PRODUCT/PROCESS CHANGE NOTICE (PCN)

PCN #: **A1401-01** DATE: **7-Mar-2014**

Product Affected: **5.0mm x 7.0mm CDIP-10**

ATTACHMENT I - PCN # : A1401-01

Detail Of Change:

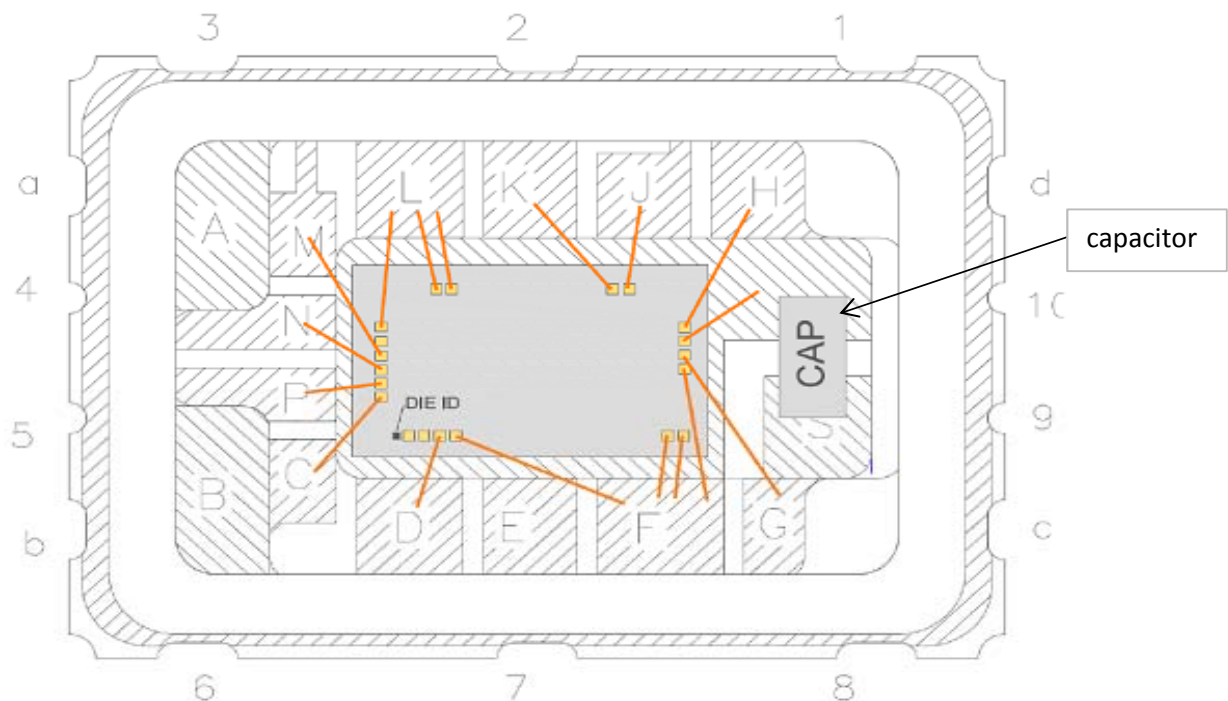
This notification is to advise our customers that IDT has qualified an alternate capacitor used internal to the package of 5.0mm x 7.0mm CDIP-10. Refer to below illustration.

This alternate capacitor was designed with these key features:

1. End cap shape to optimize mounting with conductive cement.
2. Reduce the use of gold.
3. Exceptionally high reliability for the auto industry application.

There will be no changes to the following elements:

1. Finished package
2. Seam sealed cover
3. IC used
4. Quartz crystal used
